BID No. 2020-021 - ADDENDUM #1

**SOLICITATION OF BIDS
THERMAL REMEDIATION OF VOLATILE ORGANIC COMPOUNDS
FORMER WASTEWATER TREATMENT FACILITY
SARL DRIVE
SALEM, NEW HAMPSHIRE**

Date: January 15, 2021

卷之二

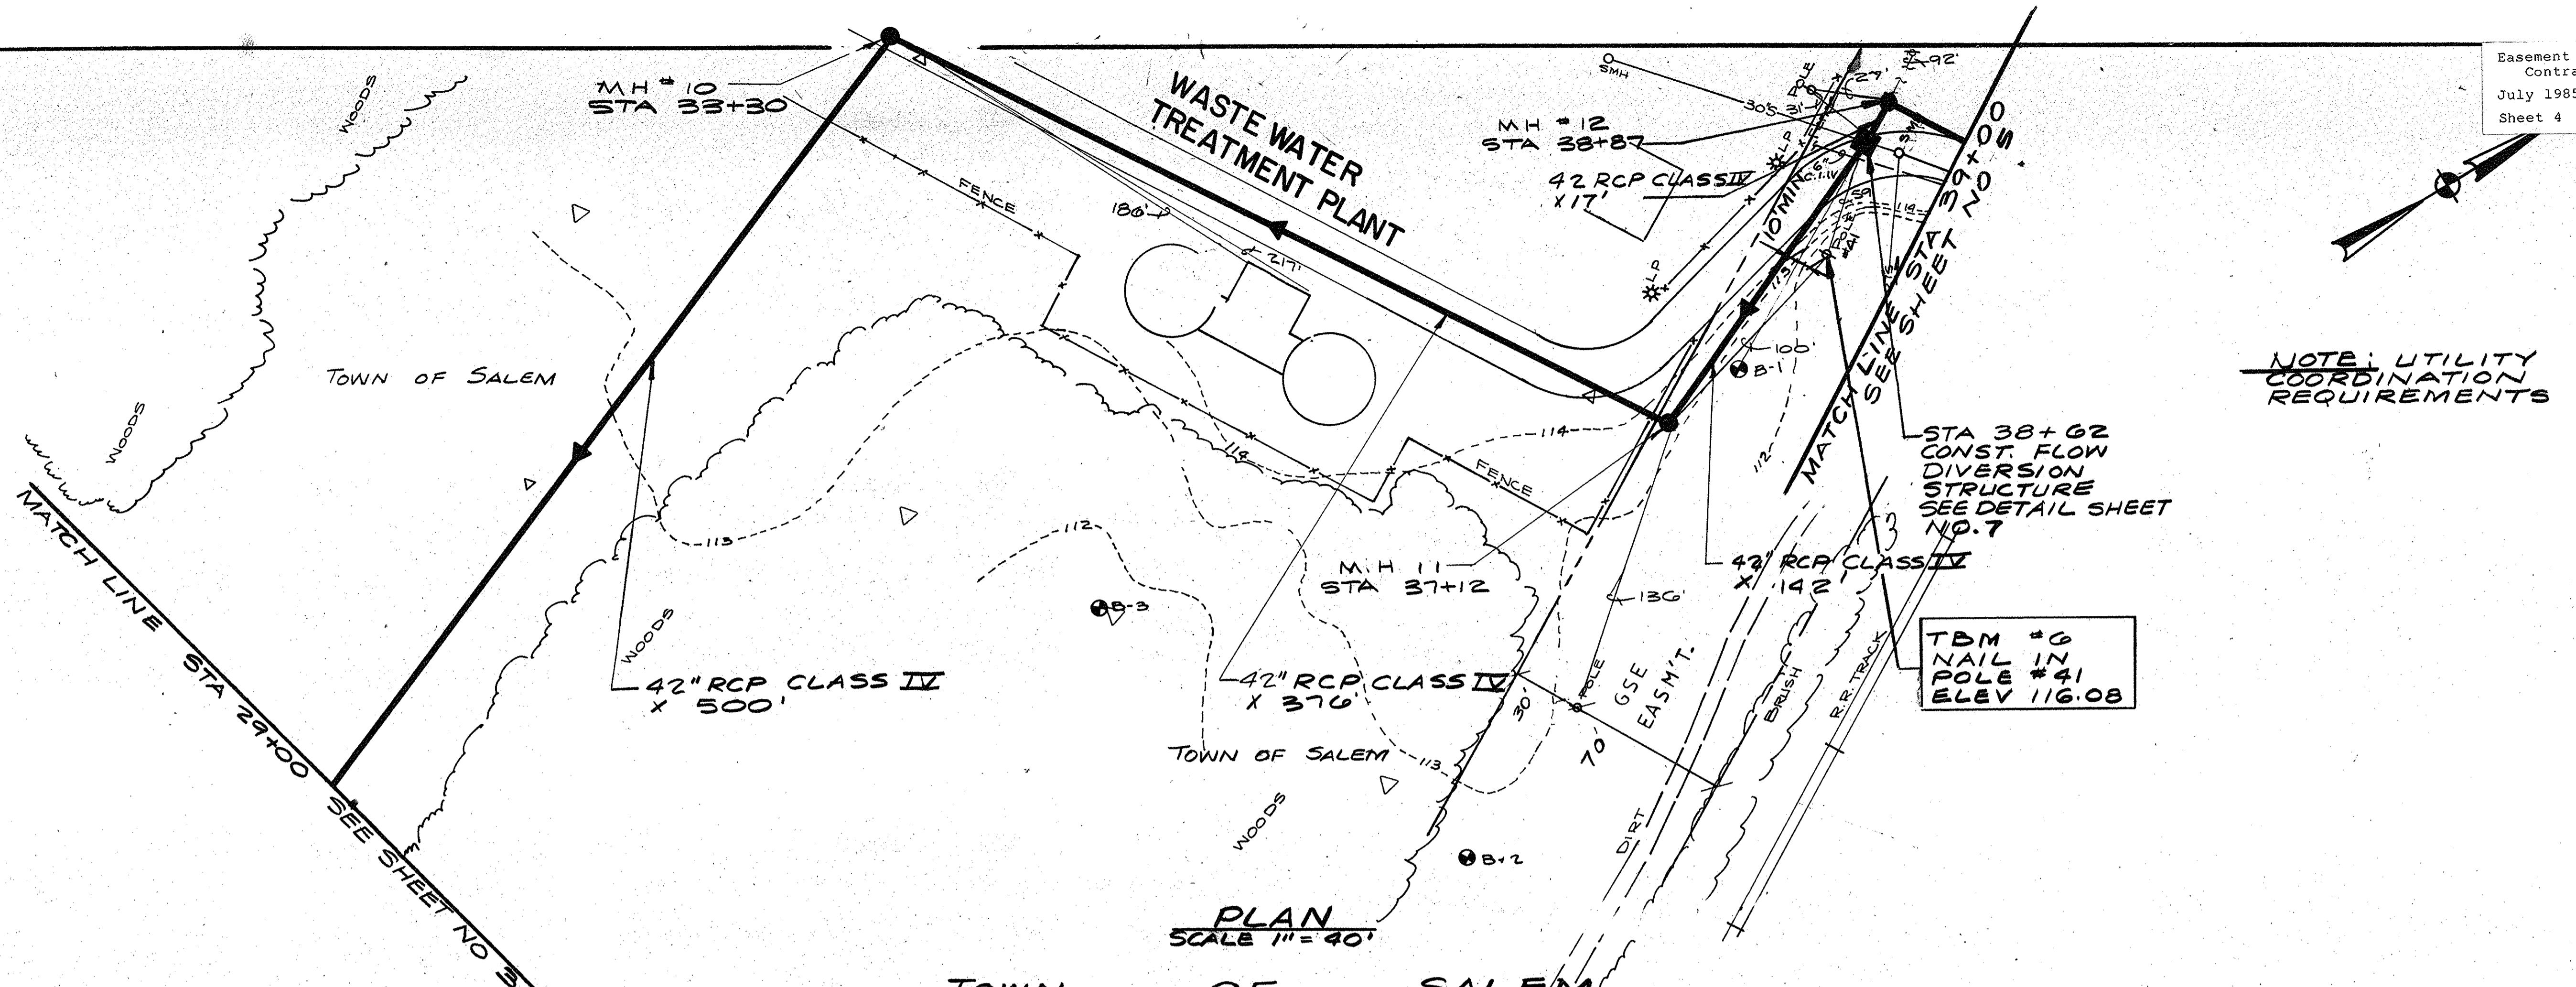
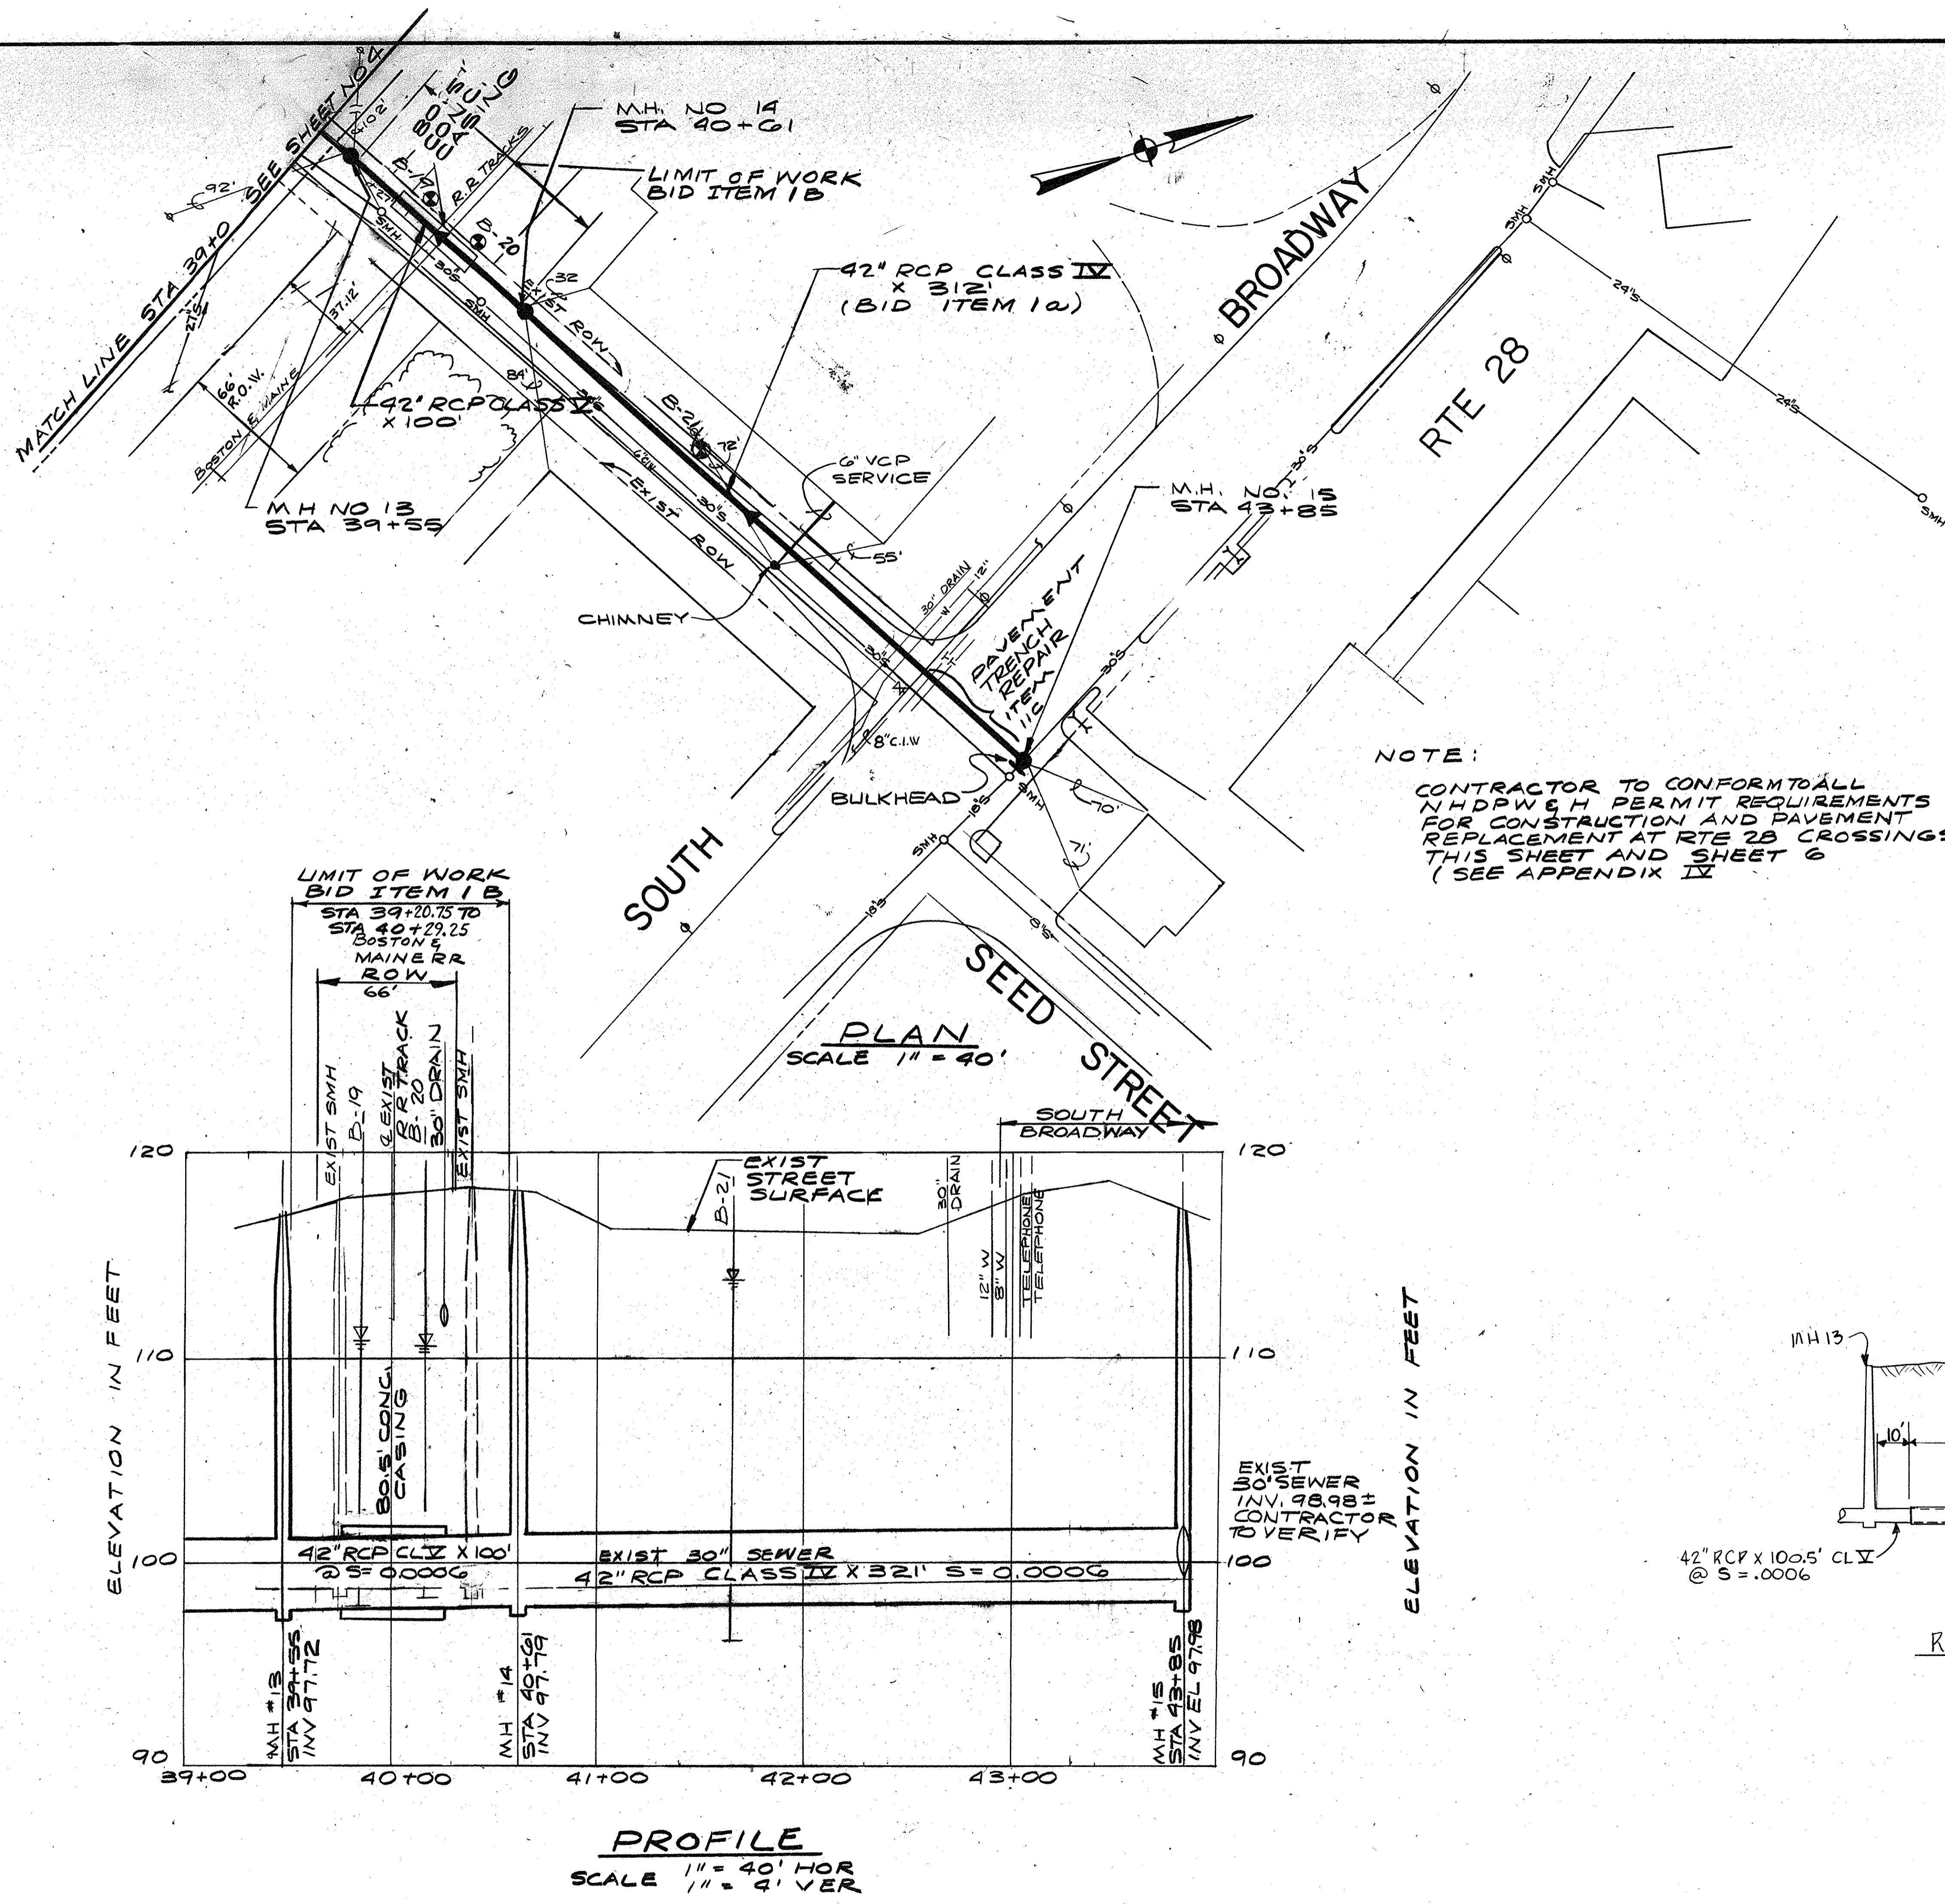
Question: What are the sewer line specifications such as materials, construction details, installation depths, etc?

Response: As-built plans for the 42-inch reinforced concrete pipe (RCP) as presented in Attachment B. Attachment B also include portions of a GZA site plan showing the 42" RCP sewer line.
